Access Compliance Report

Public Rights-of-Way

Intersection ID: 44204	Main Street: MOCKERNUT_DR	Cross Street: COFFEE_TREE_CT	Location: NW
ADA ID: 0A9EAC5DEE7F	Ramp Type: BlendTrans1	Initial Pass/Fail: Pass	Overall Compliance: No
		Severity Score: 0.25

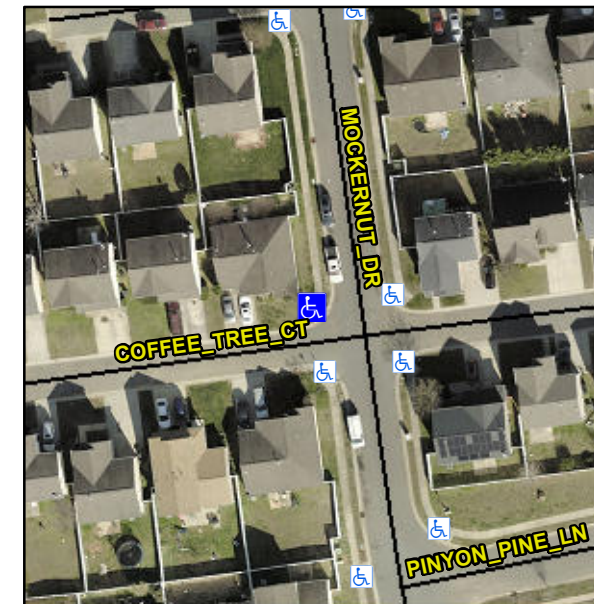
Surveyor Notes:

NO LT SW

PROW/ADA:

Not Found, R304.5.3, R304.2.1, R305.2

Possible Solutions:

Remove & Replace Curb Ramp With Two New Directional Ramps or Equivalent. Remove & Replace Gutter.
